**S16 Application for Permission of Approved Tai Po
Outline Zoning Plan No. S/TP/31
Proposed Re-zoning from “AGR” to “G/IC” for a
Proposed Change of Use to “Social Welfare Facilities”
(RCHE) in “Green Belt” & “Village” Zone at Various Lots
in Lai Chi Shan, Tai Po, N.T.**

TIA Report

**S16 Application for Permission of Approved Tai Po Outline Zoning Plan No. S/TP/31
Proposed Change of Use to “Social Welfare Facilities” (RCHE) in “Green Belt” &
“Village” Zone at Various Lots in Lai Chi Shan, Tai Po, N.T.
TIA Report
Summary of ‘Responses to Comments’ (September 2026)**

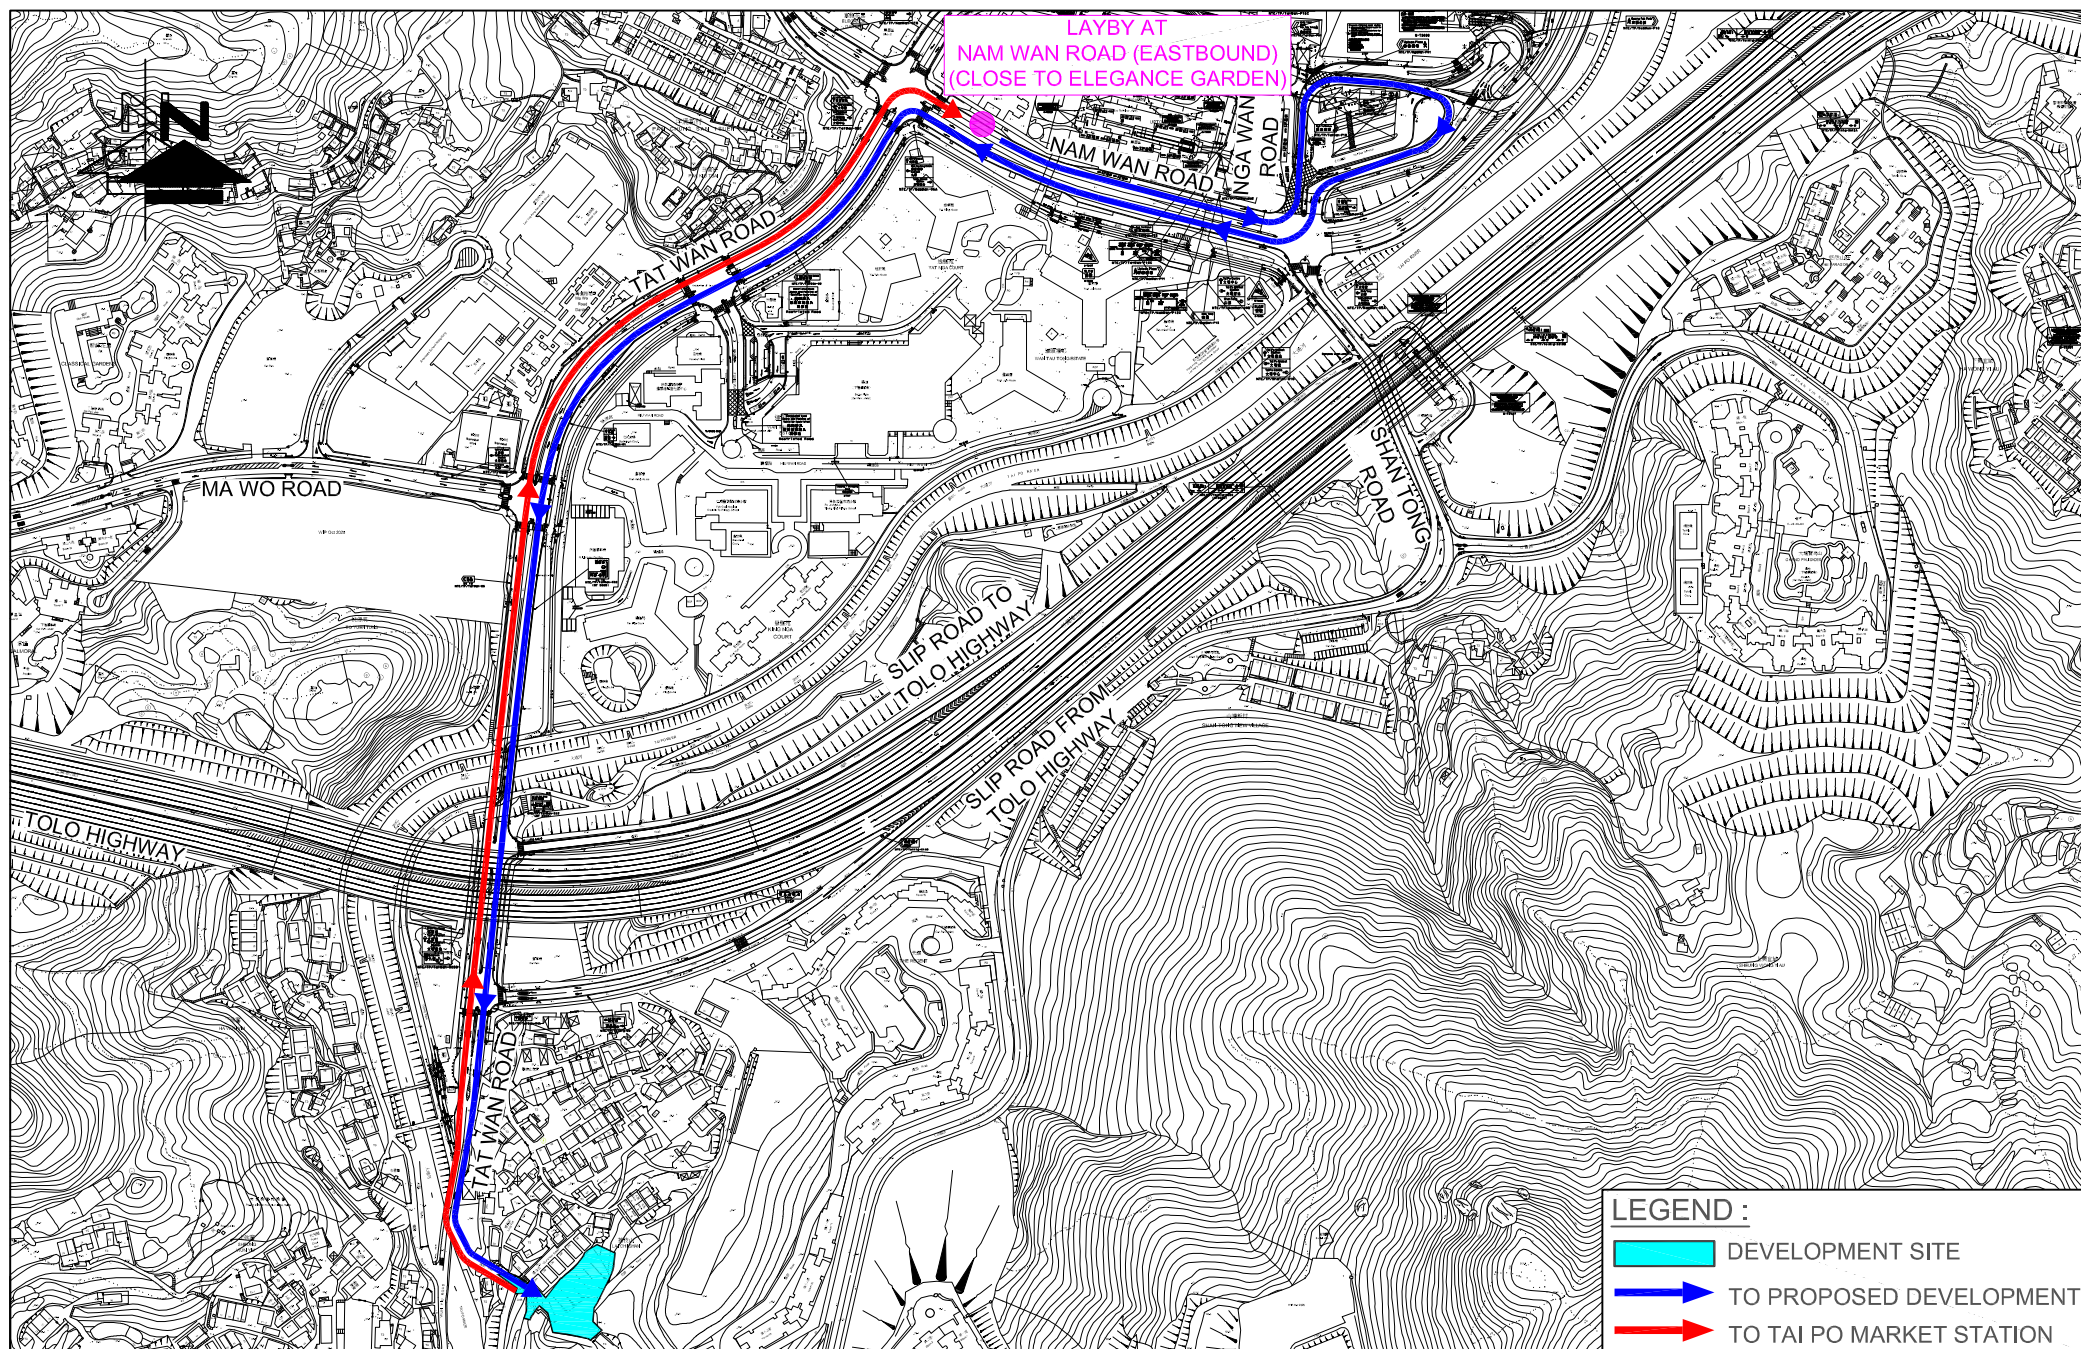
5. Comprehensive details of the proposed road improvement works must be included in the TIA report, which is currently missing in the report.	Please refer to Figure 2.1 (Rev A) of the revised TIA report for the proposed road improvement works.

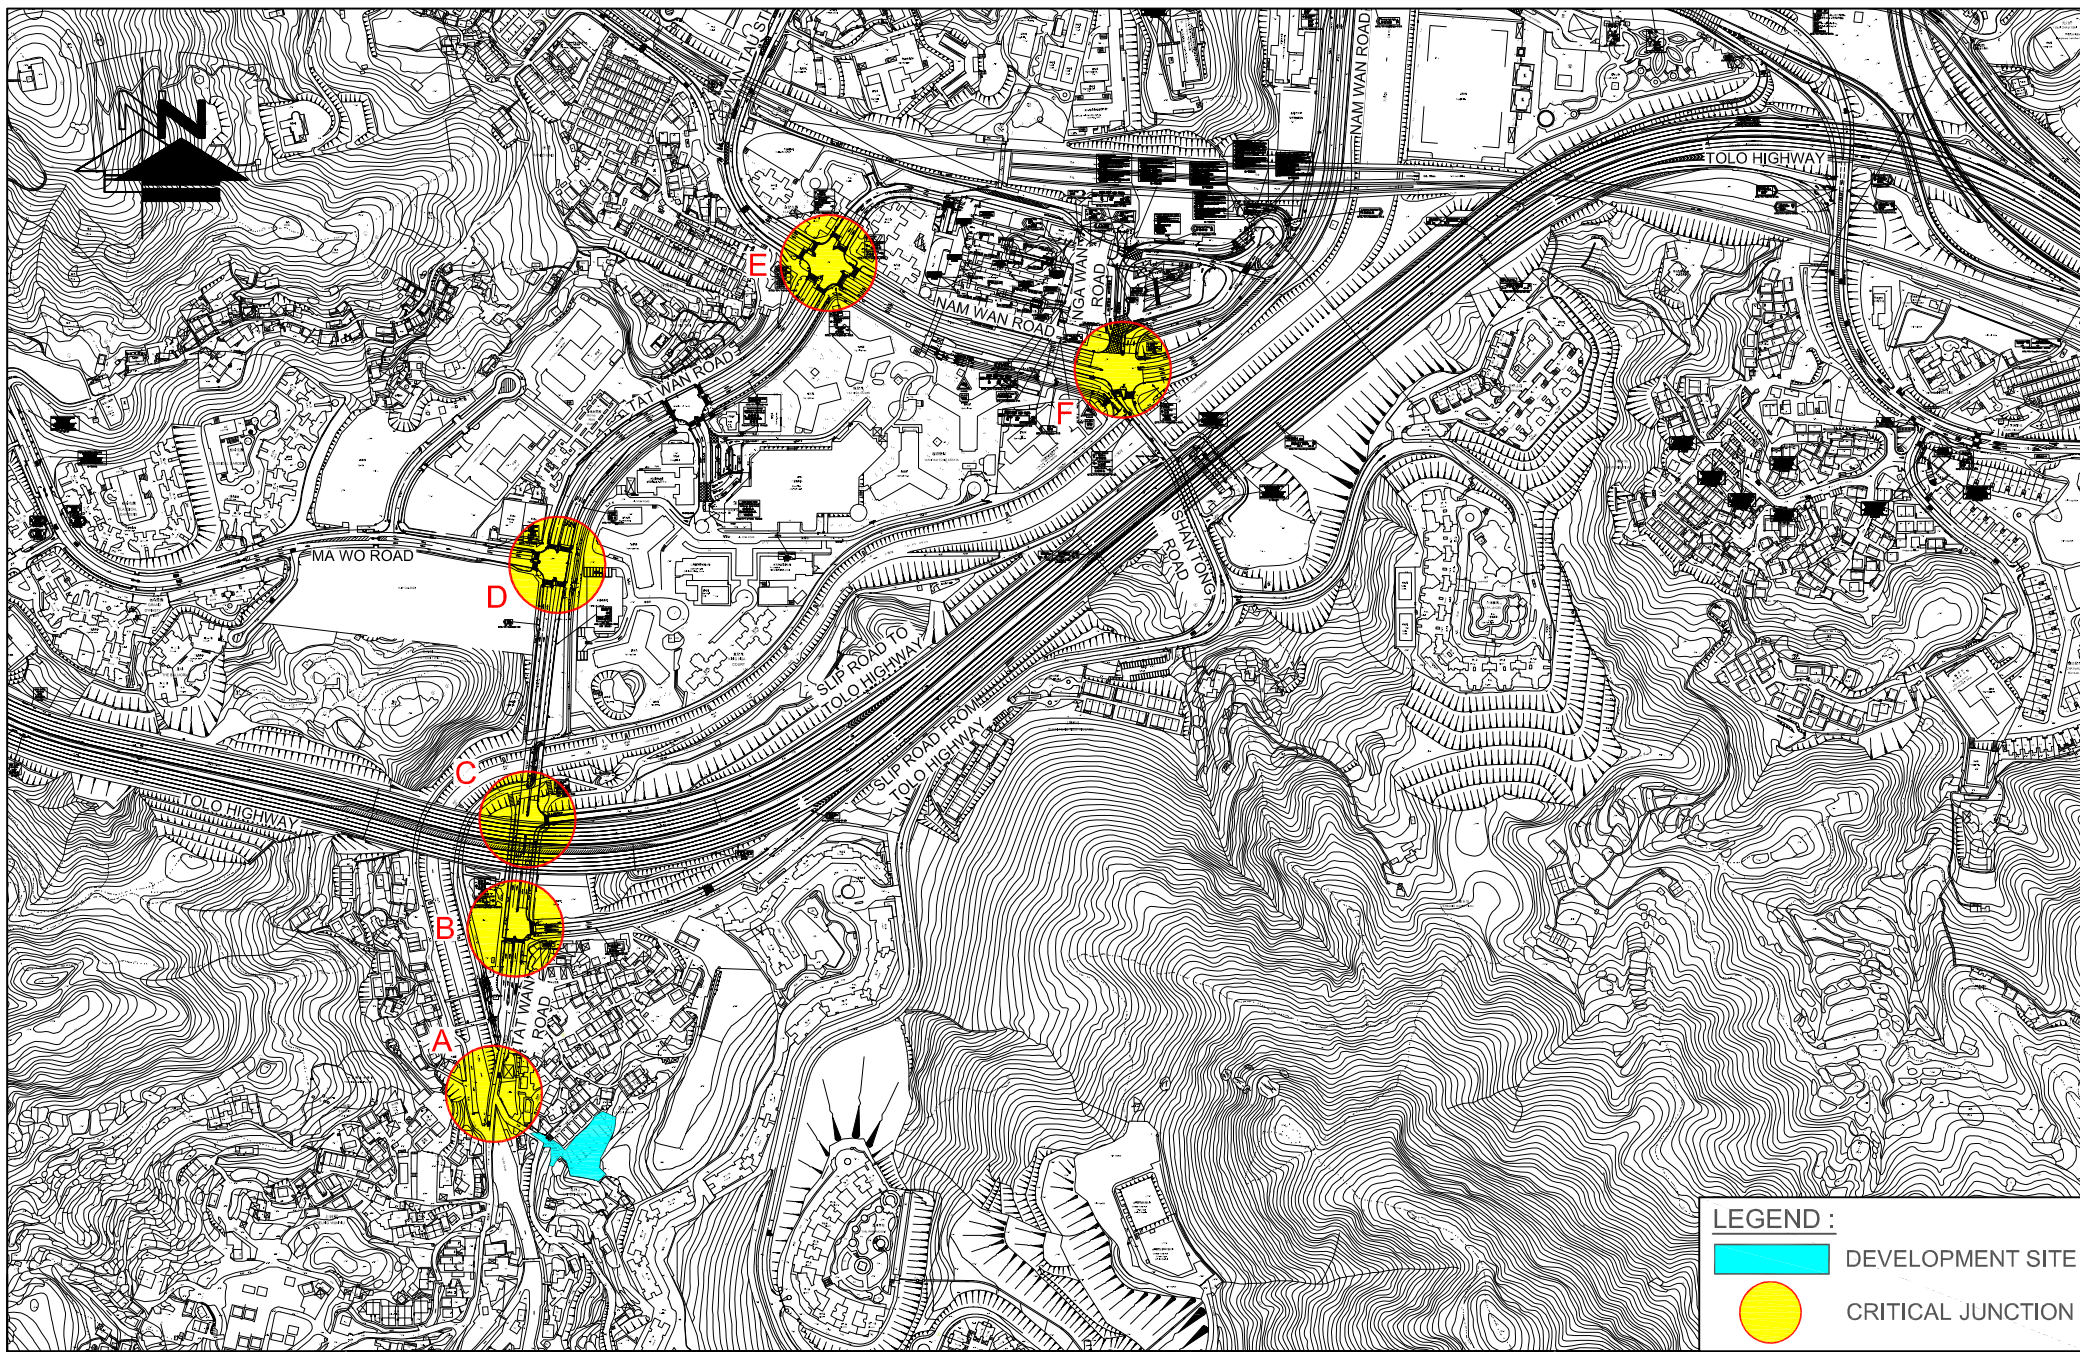
7. It is noted that the nearest bus stop is currently missing from Table 2.4 and Figure 2.2.	Noted and please note that the nearest public transport stop has been added, please refer to Figure 2.2 (Rev A) of the revised TIA report for details.

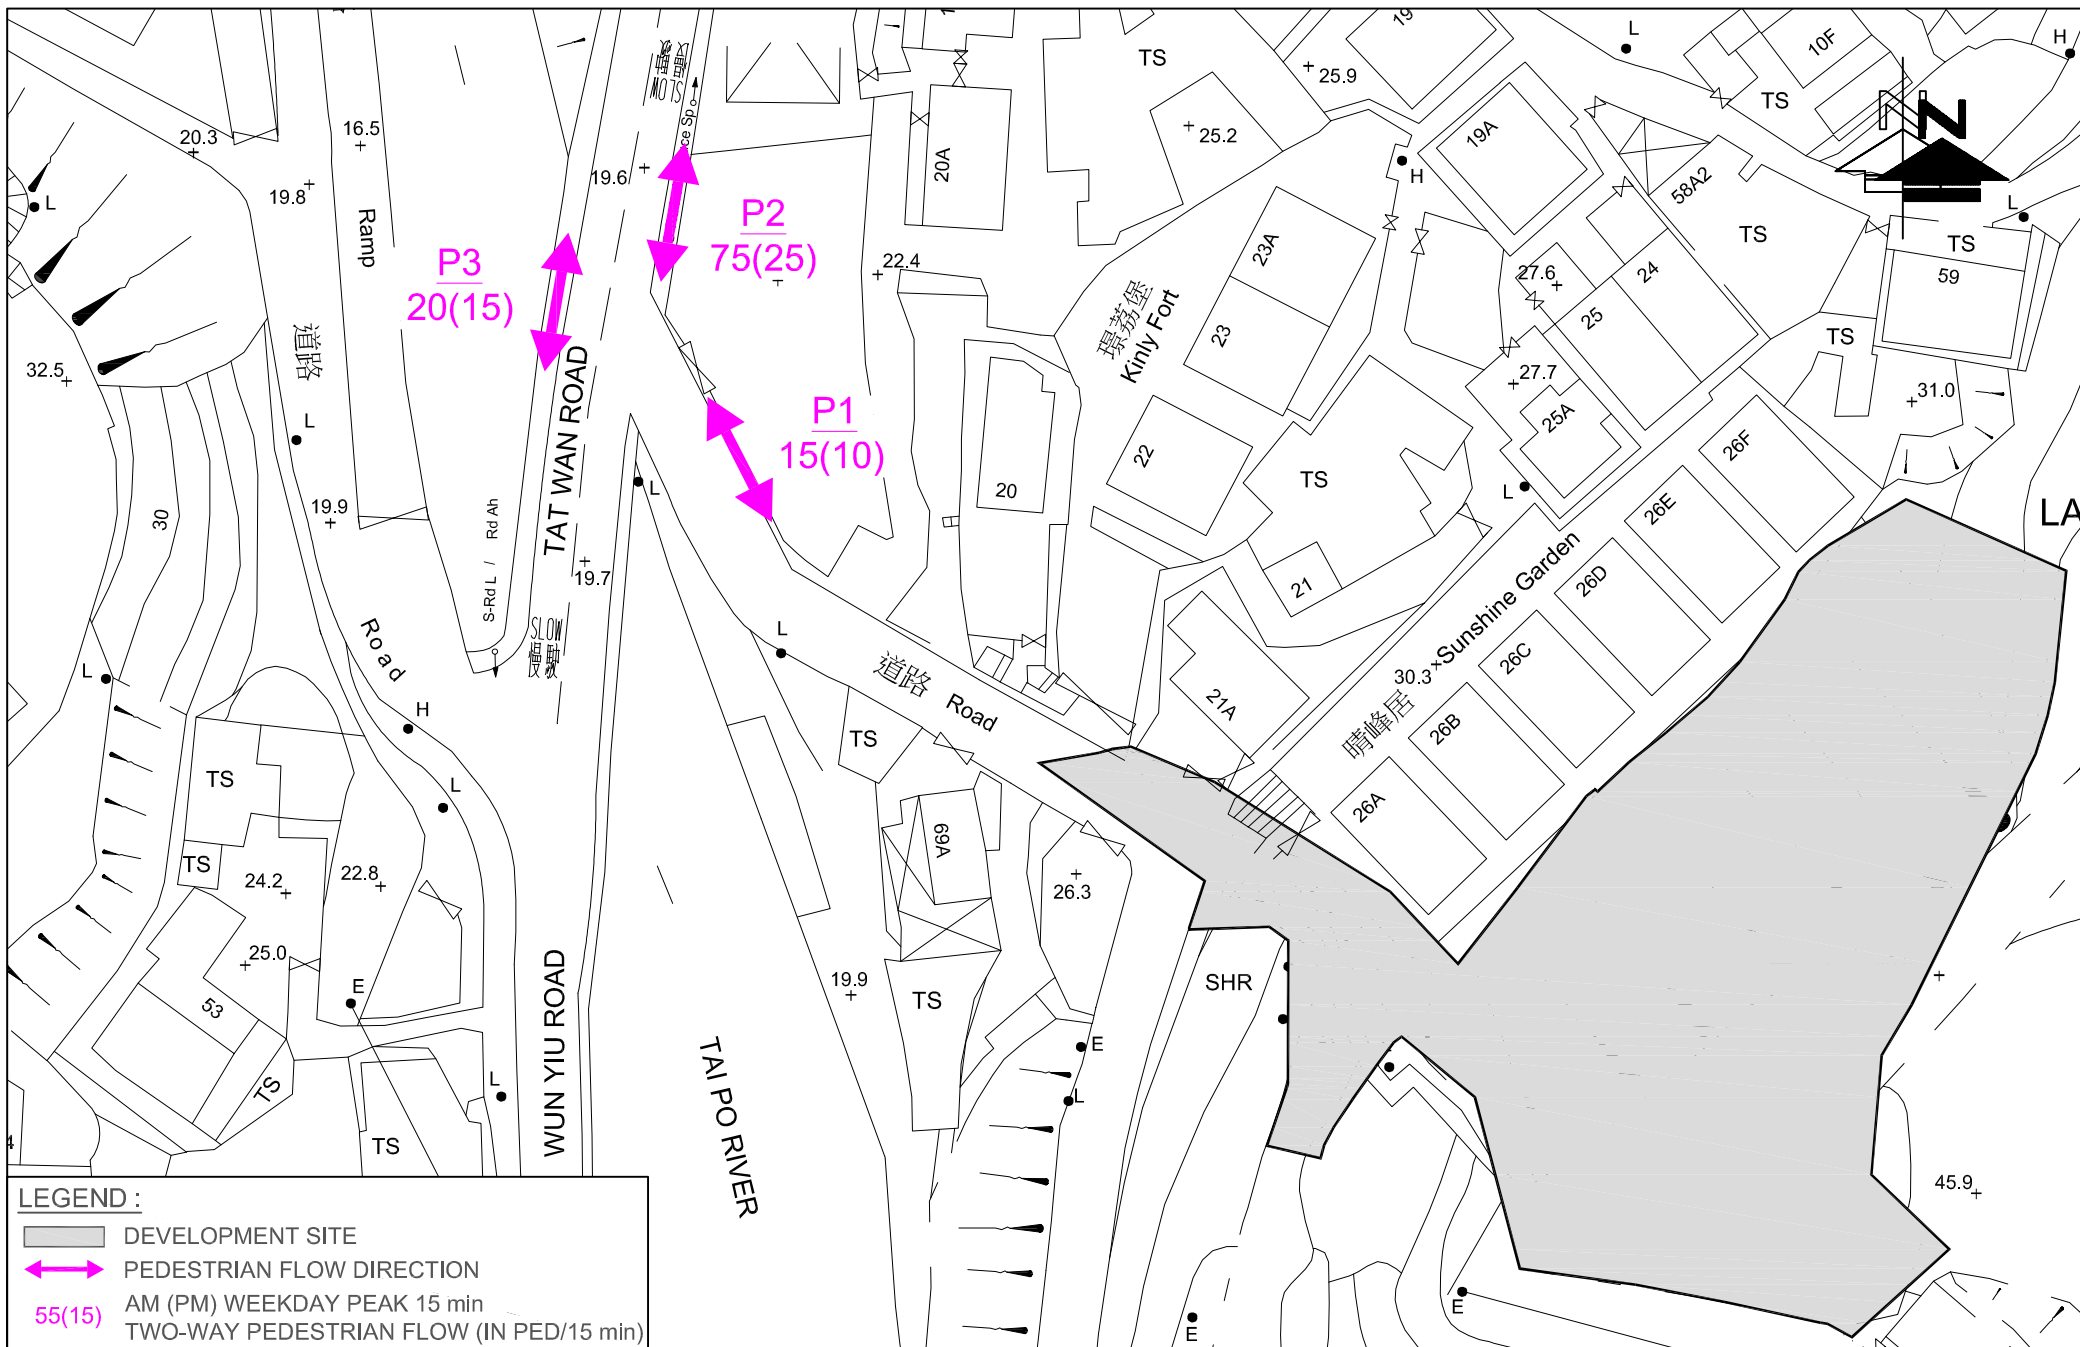
6. Please also provide a drawing showing the pedestrian route to public transport facilities. Pedestrian assessment shall also be provided.	Please refer to Figure 7.1 of the revised TIA report for pedestrian route to public transport facilities. Please note that pedestrian assessment has been added, please refer to Section 7 of the revised TIA report for details.
